## RESPONSE TO REQUEST FOR ADDITIONAL INFORMATION

### APR1400 Design Certification

RAI No.: 16-7915

SRP Section: 08.01 – Electrical Power – Introduction

**Figure 8.1-1 Electric Power System Single Line Diagram (Division I) (1 of 2)**

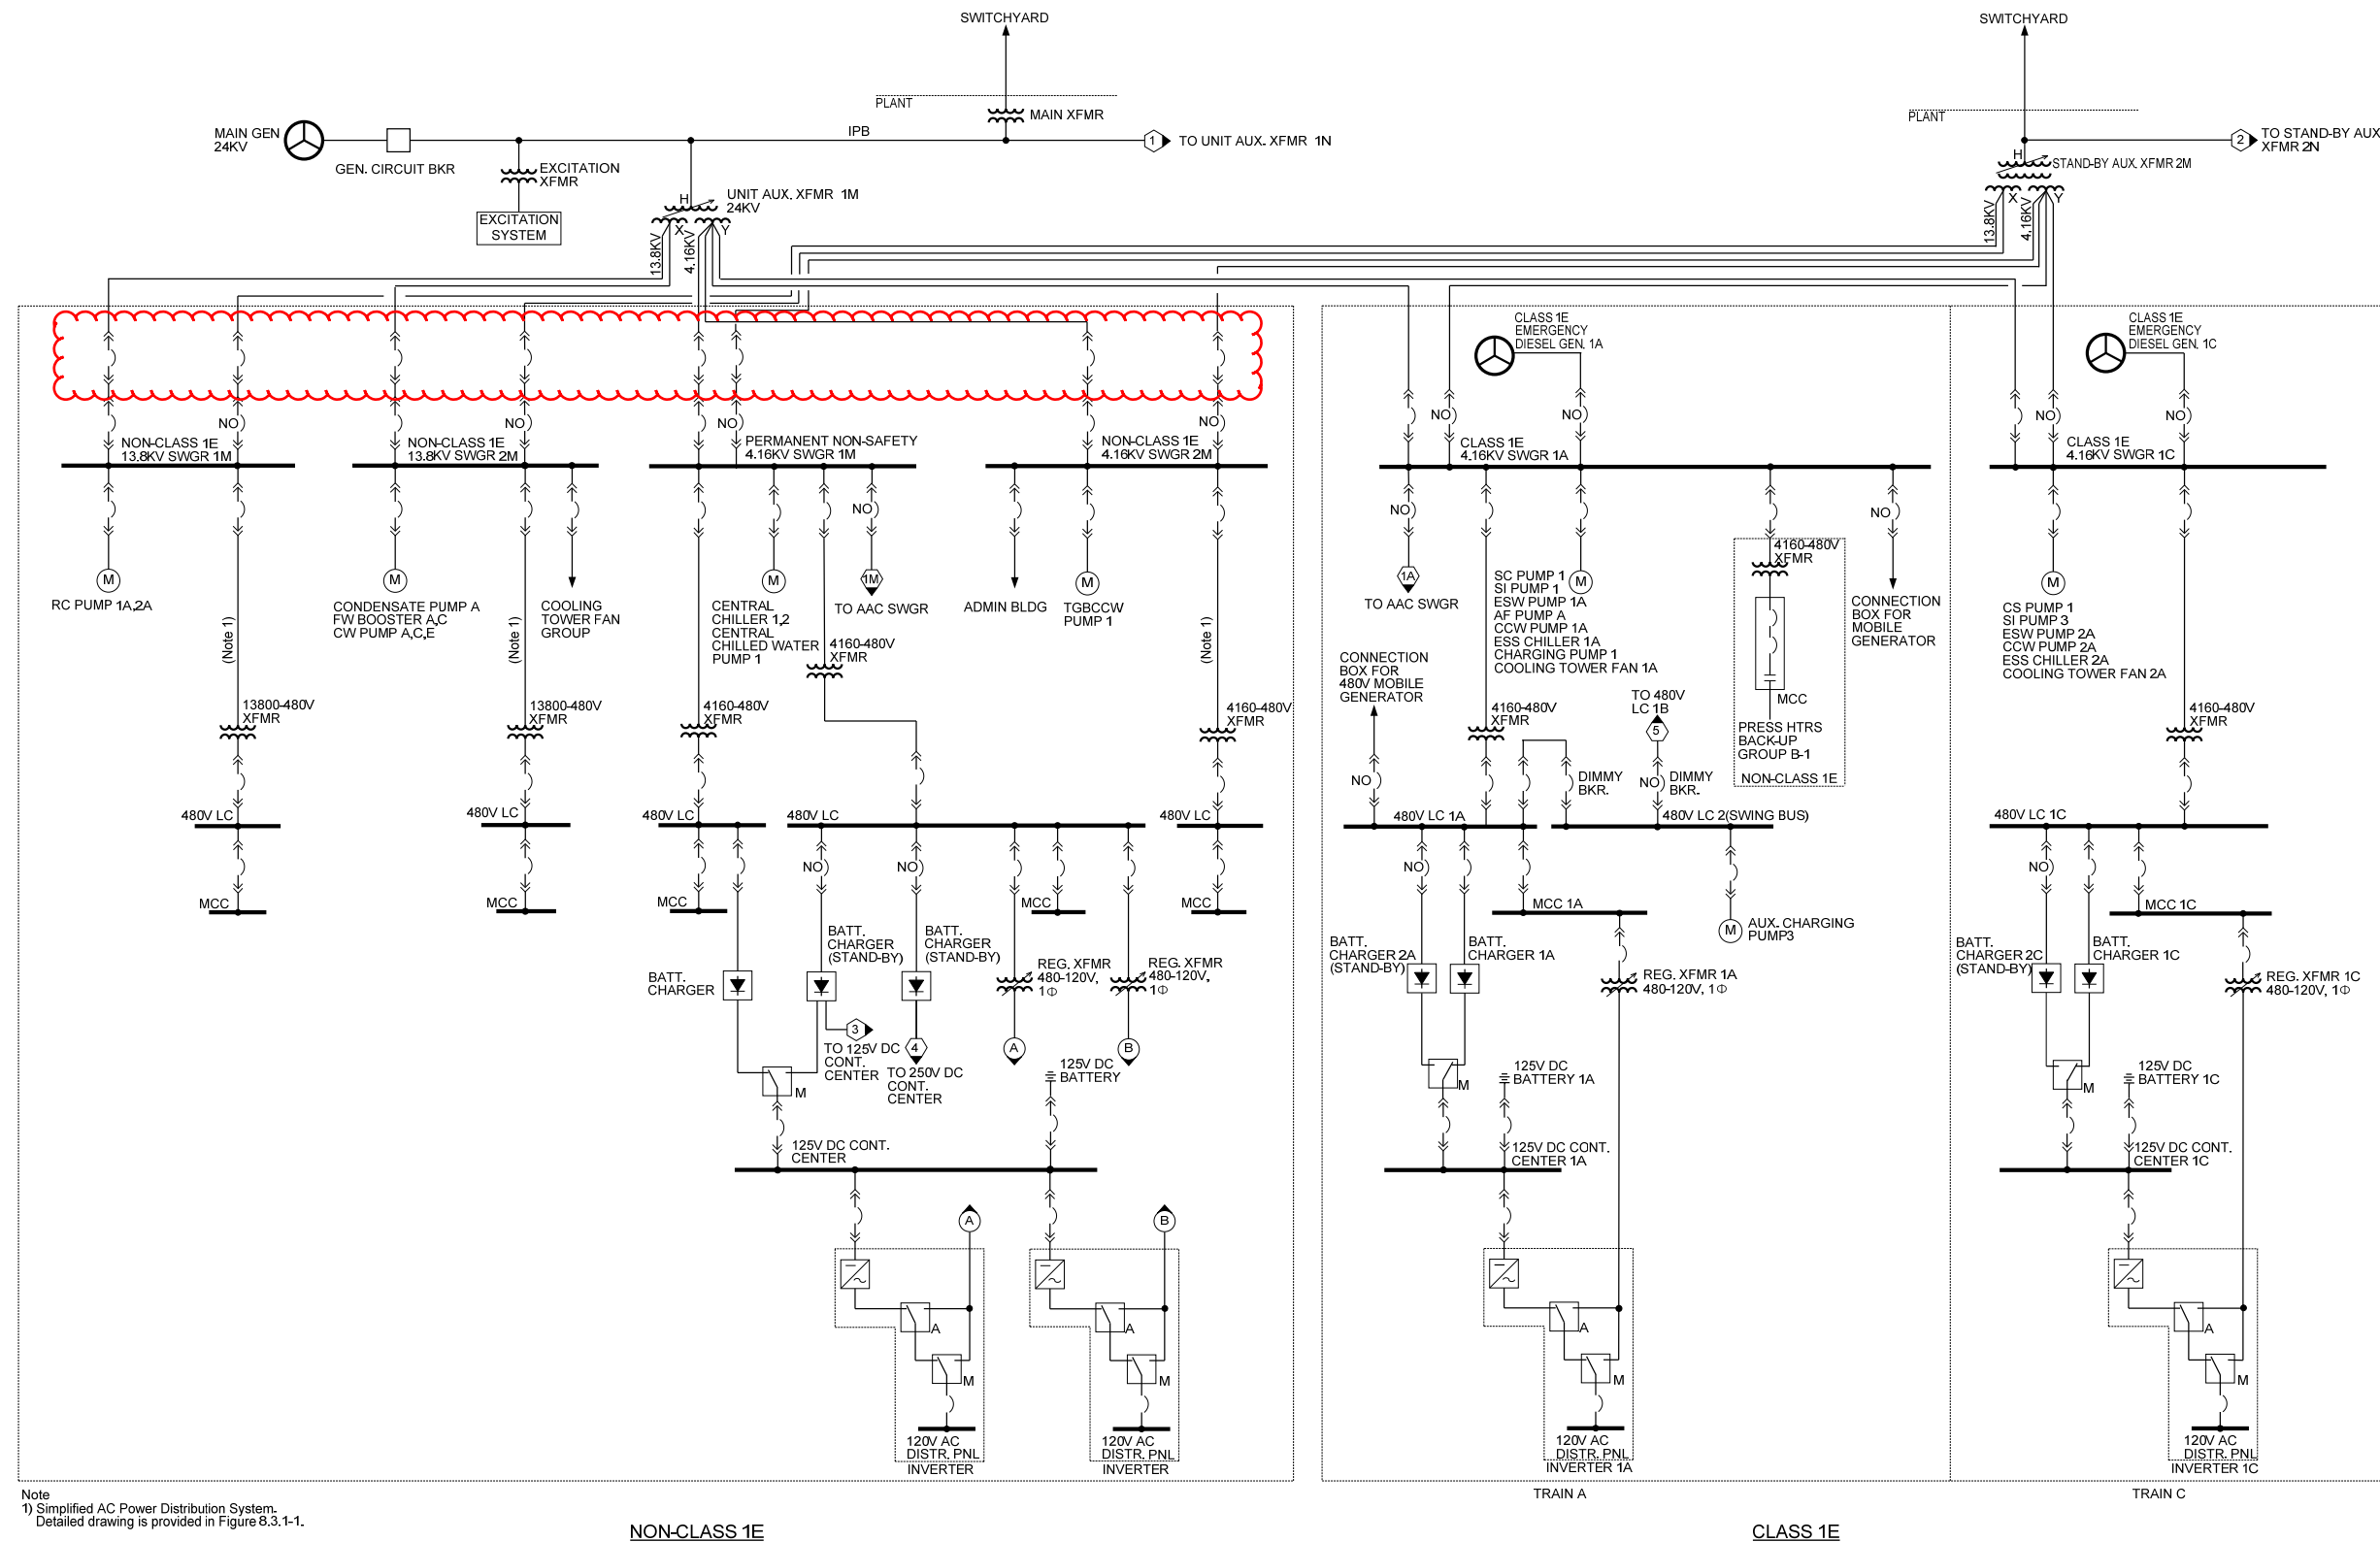
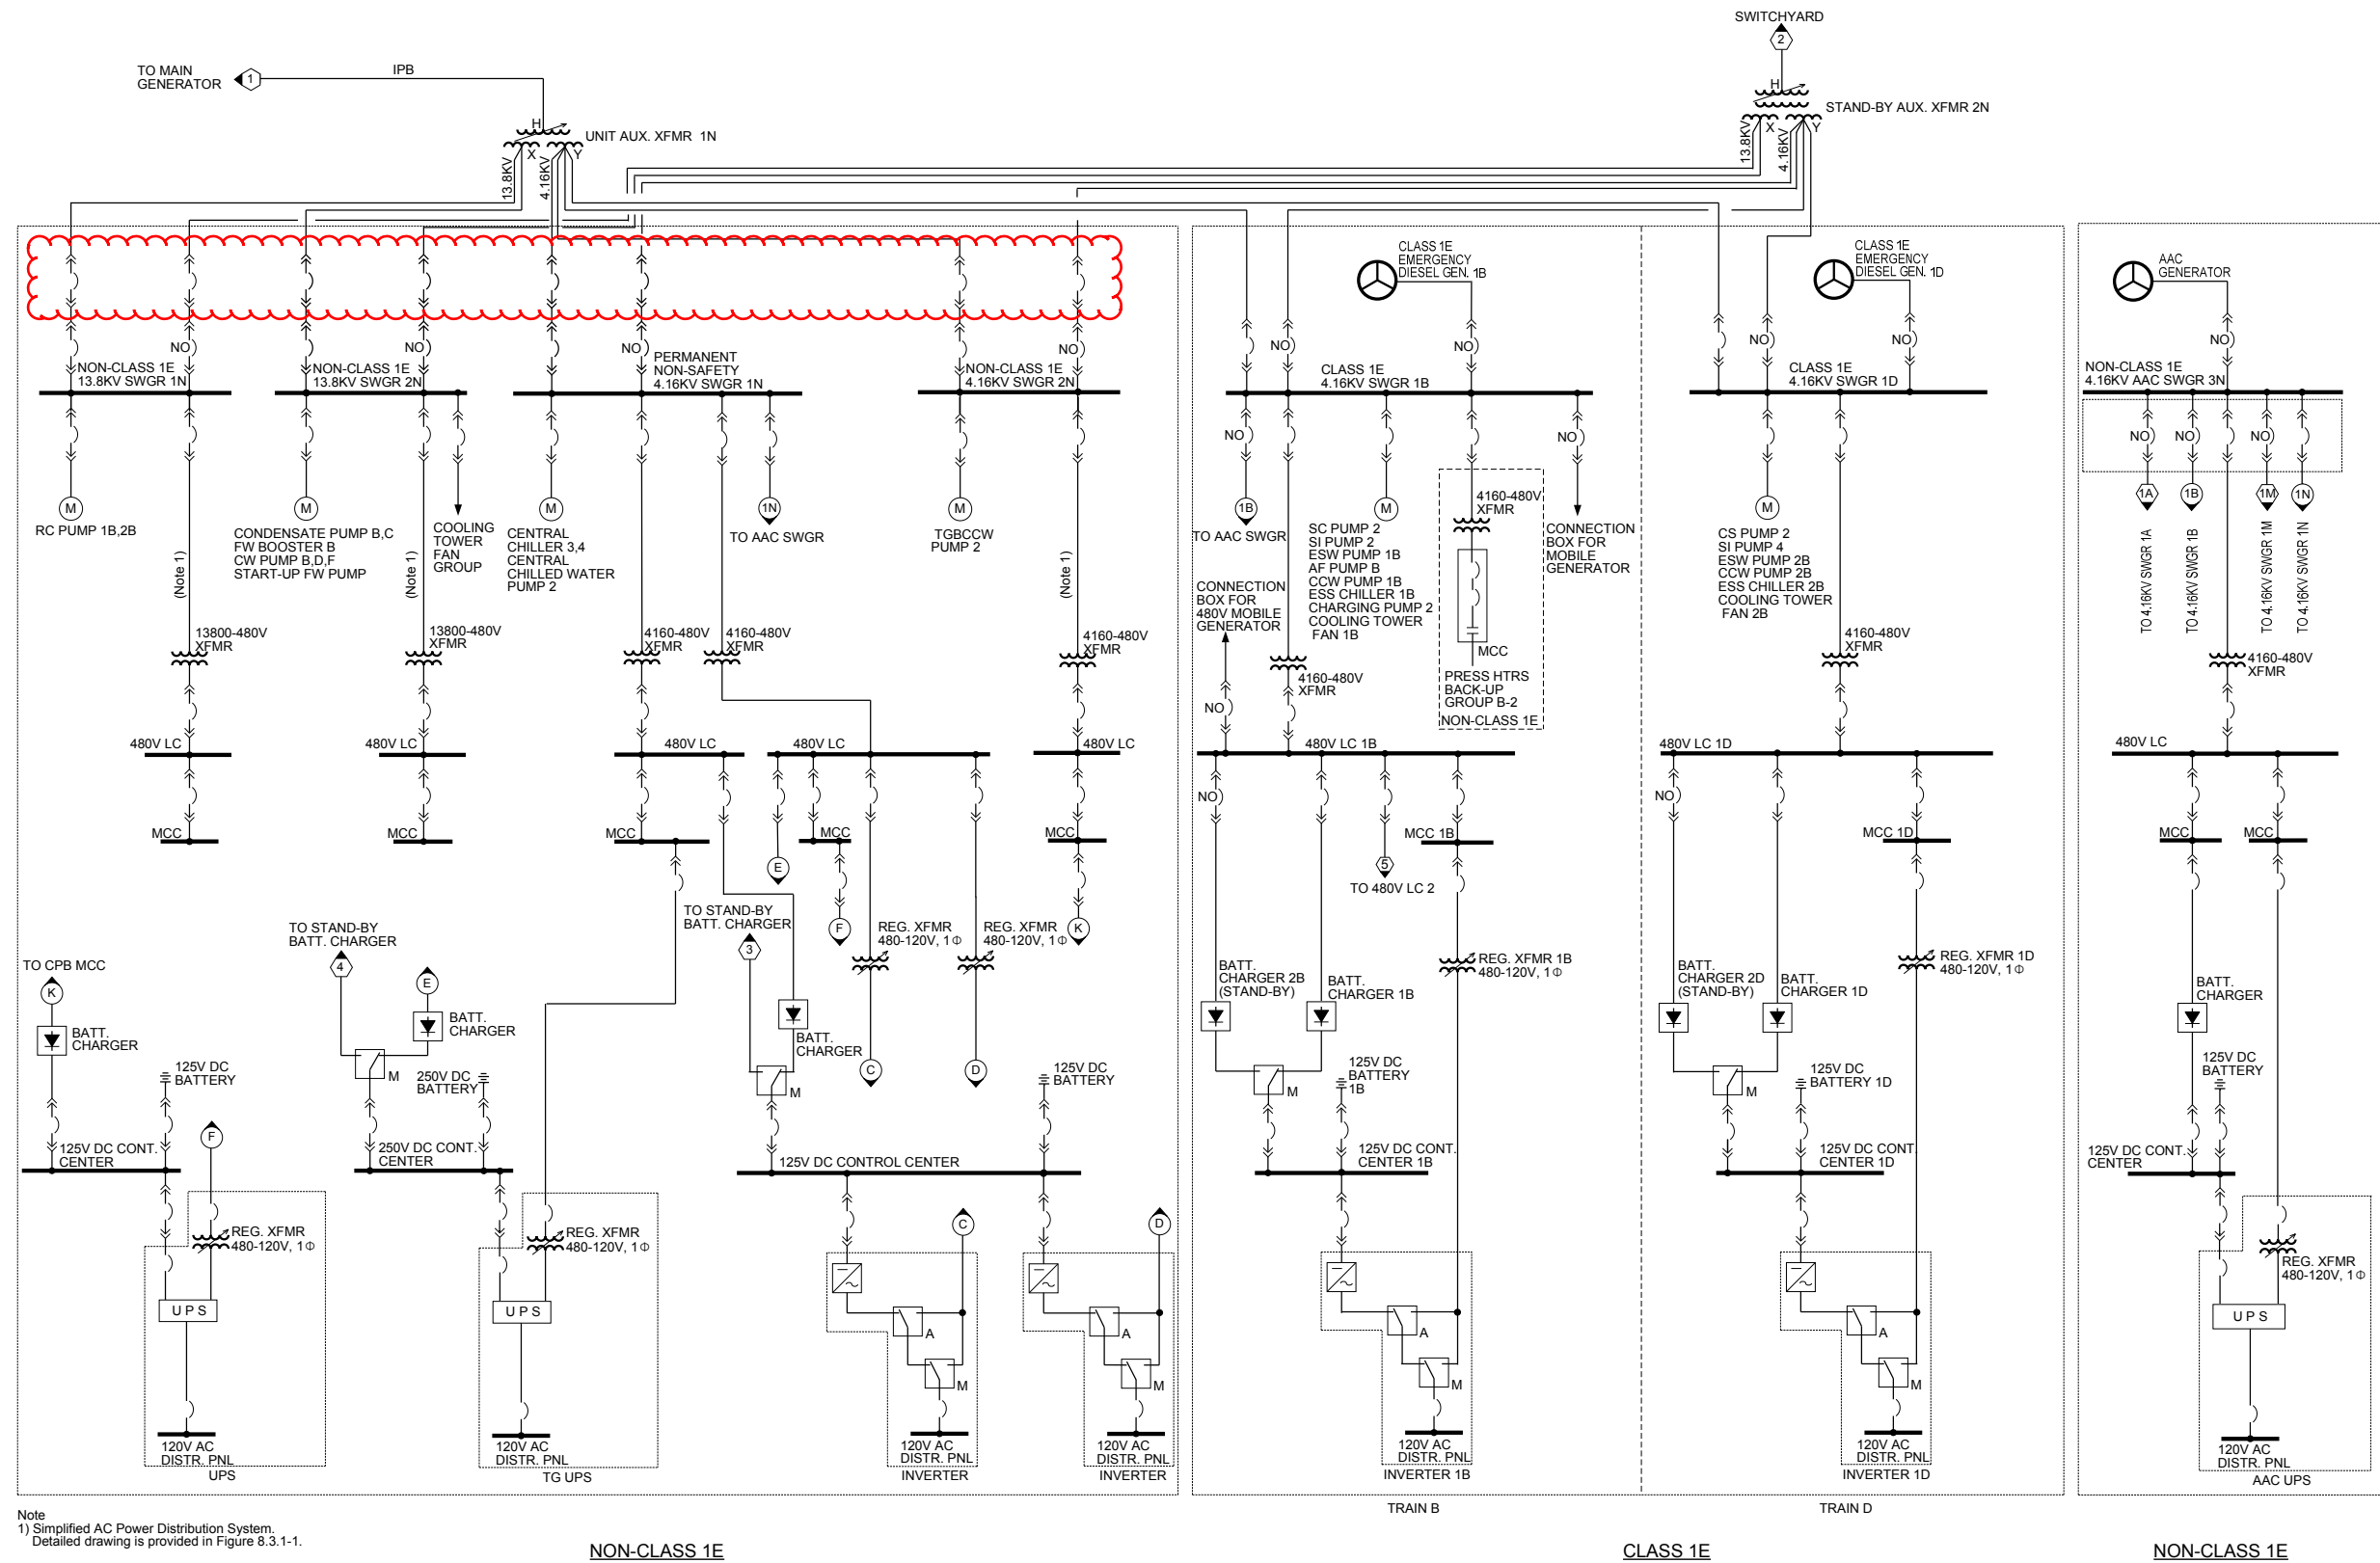
In DCD Tier 2 Section 8.1, the applicant described briefly the offsite and onsite power distribution system of the plant and referenced the Single Line Diagram Figure 8.1-1 (2 pages). These descriptions are further provided in DCD Sections 8.2 and 8.3.

The staff noted that both Class 1E and non-class 1E buses are connected to the same UAT, and similarly for the SAT, rendering the emergency Class 1E buses/switchgear vulnerable to potential failure due to a failure of the non-Class 1E bus/switchgear. In addition, the safety loads could be subjected to transients caused by the non-safety loads, and adds additional failure points between the offsite power sources and the safety loads. Therefore, the staff finds that the proposed design does not meet the SECY-91-078 requirements.

Since this configuration of the power distribution system does not meet the requirement of the SECY-91-078 and GDC 17, the staff finds this power distribution arrangement unacceptable because connecting both non-safety and safety system to common transformer windings compromises the safety system reliability with no electrical separation. According to the above SECY and per GDC 17, the staff's position is that at least one offsite circuit to each redundant safety division should be supplied directly from one of the offsite power sources (UAT or SAT), with no intervening non-safety buses, in such a manner that the offsite source can power the safety buses upon a failure of any non-safety bus.

- a) A power distribution configuration that meets the requirement of SECY-91-078, and GDC 17, such that the failure of the non-safety bus/switchgear does not adversely impact the Class 1E Emergency Power Bus/Switchgear.
- b) Revised single line diagrams and descriptions in DCD chapters that reflect any changes in the power distribution systems.

KHNP considers the current design configuration of the electrical power distribution system to the Class 1E buses complies with GDC 17 and SECY-91-078 with the following observation and design enhancements for the concerns that the staff identified in the RAI question.

Two physically independent PPS circuits are directly connected to Class 1E medium-voltage (MV) buses: one through the main transformer (MT) and unit auxiliary transformers (UATs) and the other through standby auxiliary transformers (SATs). During normal operation, the Class 1E and non-Class 1E MV buses are supplied from UATs, connected to the MT. In case of a loss of power from the UATs, the Class 1E and non-Class 1E MV buses are automatically transferred to the SATs.

Each UAT and SAT has a 13.8 kV and a 4.16 kV winding on the secondary side. The 13.8 kV winding is connected to two non-Class 1E 13.8 kV buses and the 4.16 kV winding is connected to two Class 1E 4.16 kV buses, one non-Class 1E 4.16 kV bus and one permanent non safety 4.16 kV bus.

- a) Two independent circuit breakers (thus, doubling the incoming breakers), connected in series, are used as a set of incoming breakers for all non-Class 1E 13.8 kV and 4.16 kV switchgears. This design enhancement significantly reduces the probability of failure of the non-Class 1E incoming breakers in case of a bus fault.
- b) Of the two independent circuit breakers, only one circuit breaker will be used for switching operation as well as protection while the other only for protection.
